SPRINGS AT RIVER CHASE  
CLUBHOUSE SWIMMING POOL  
1776 CONTINENTAL DRIVE COVINGTON, LOUISIANA 70433 - ST. TAMMANY PARISH

Project No: 82-16000-LA

CODE COMPLIANCE, CALCULATIONS, & NOTES

G-1.0

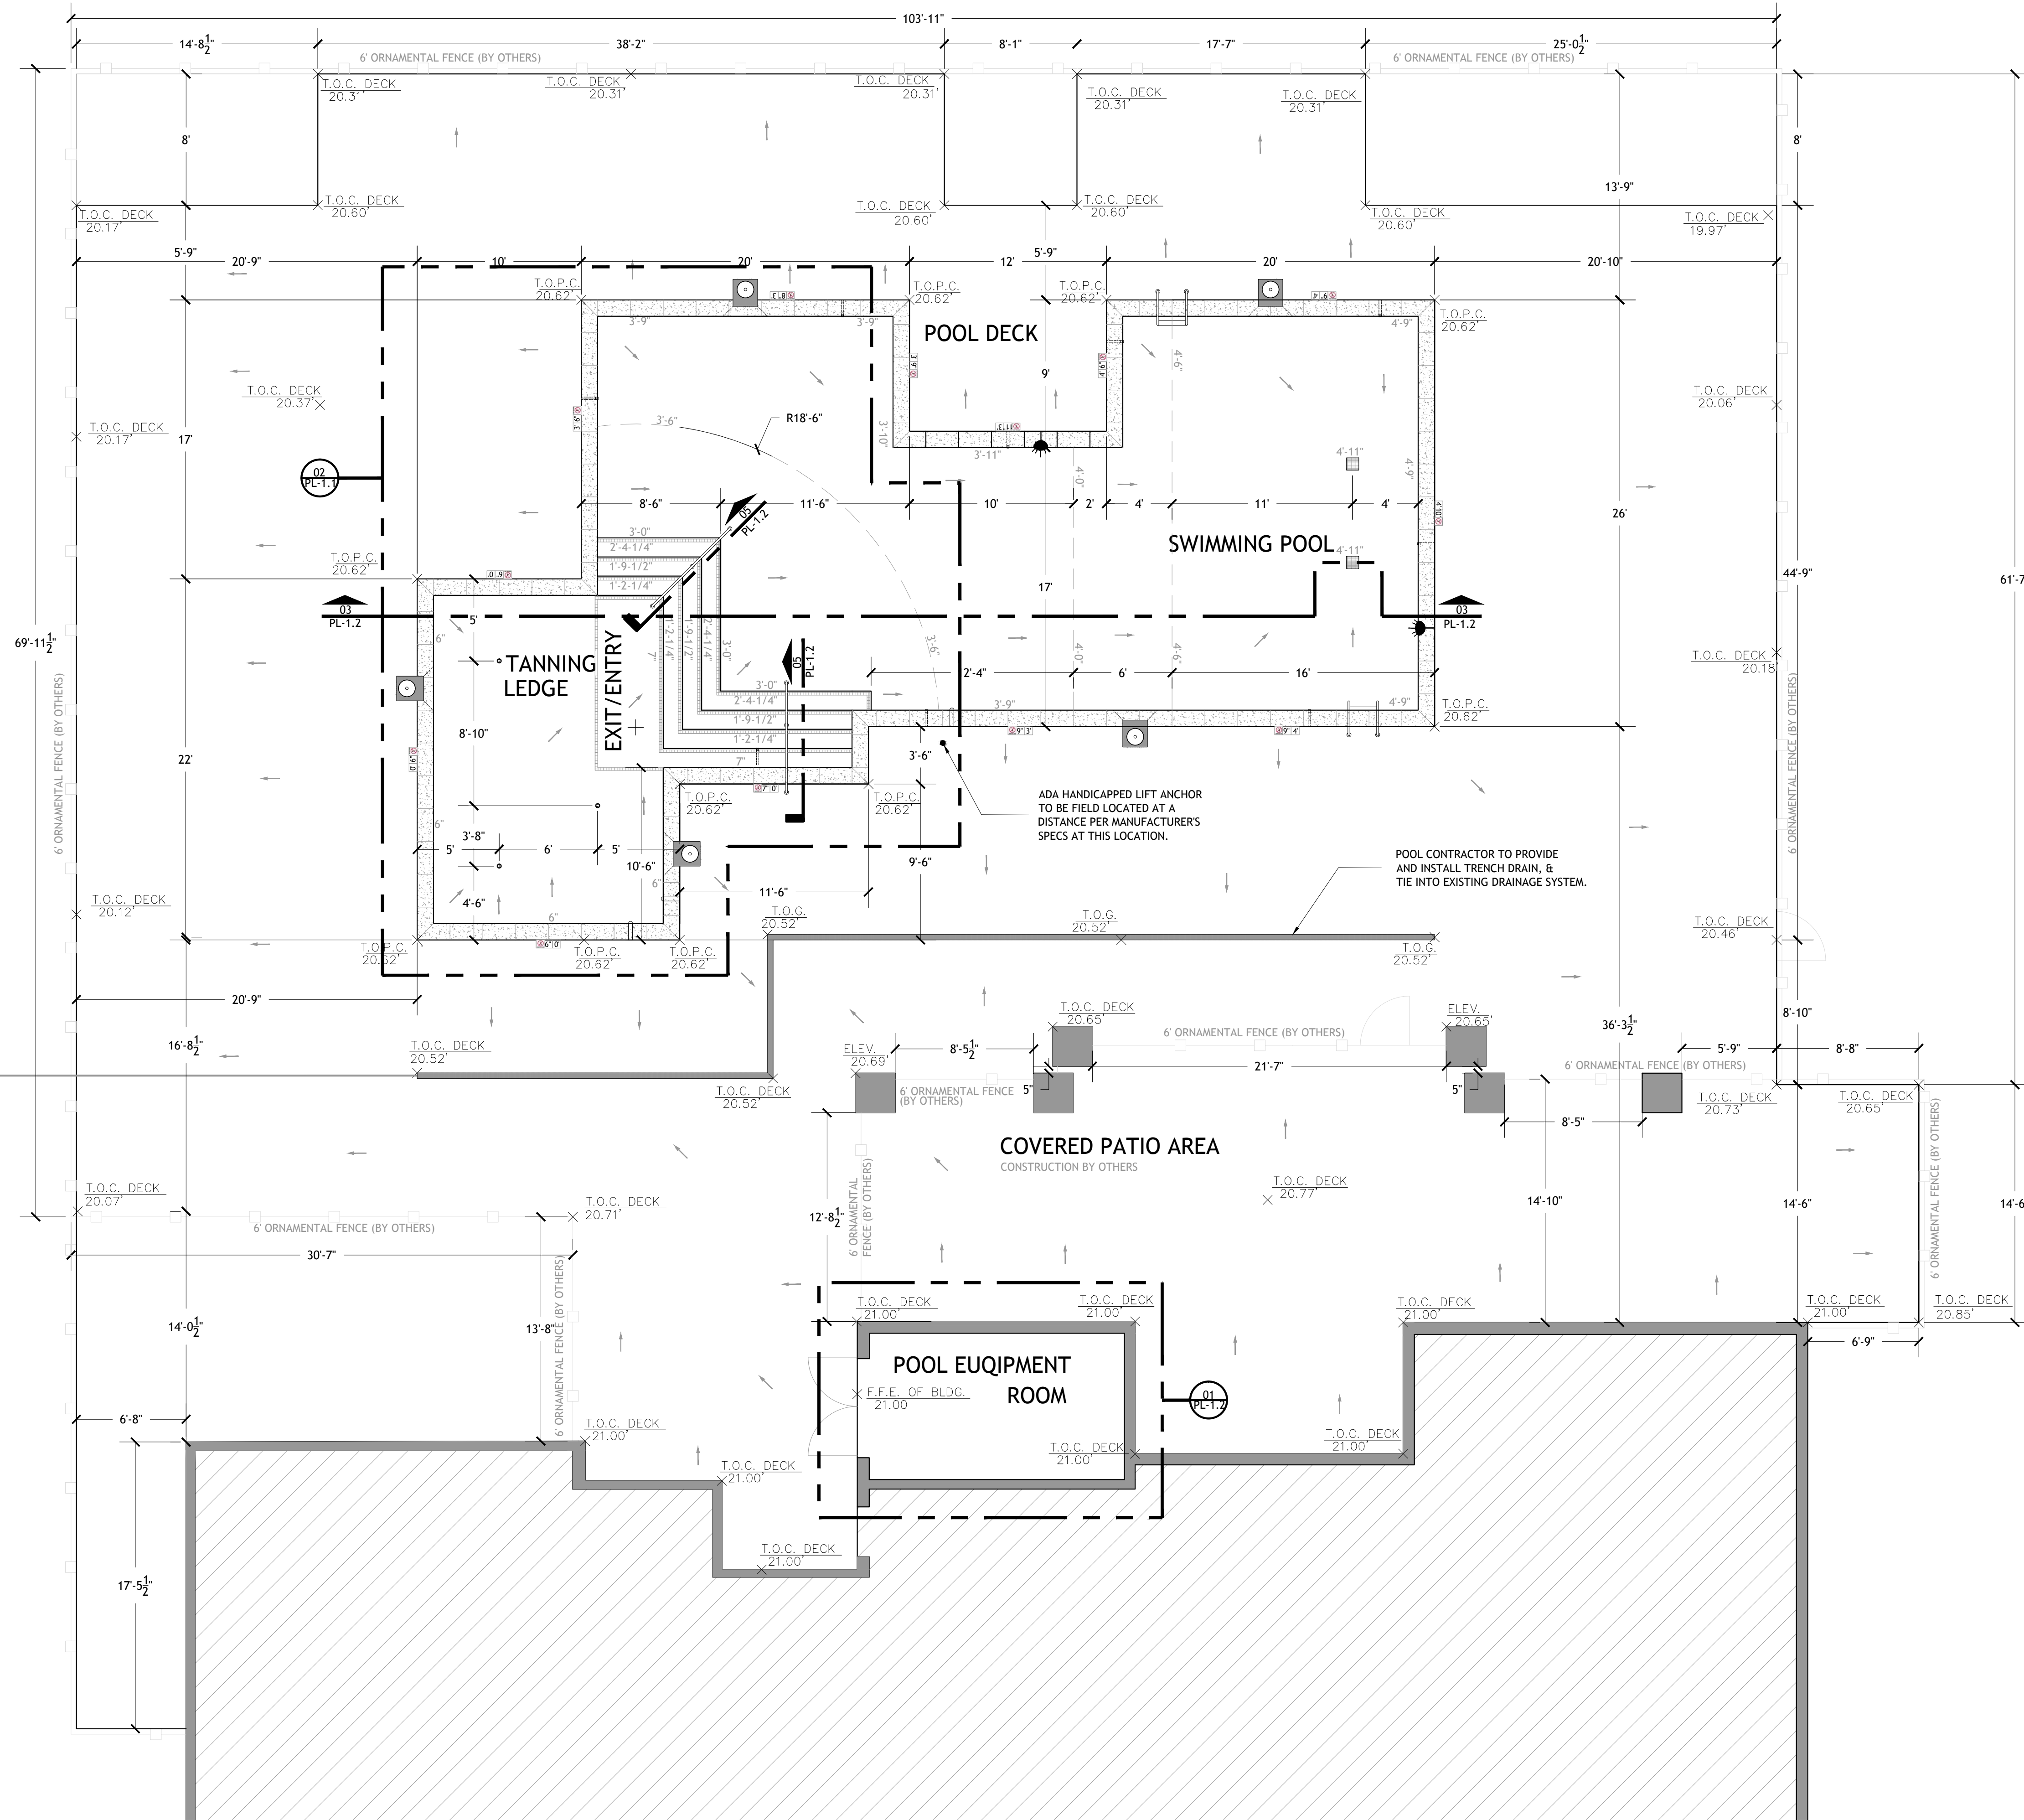
REMOVE THIS
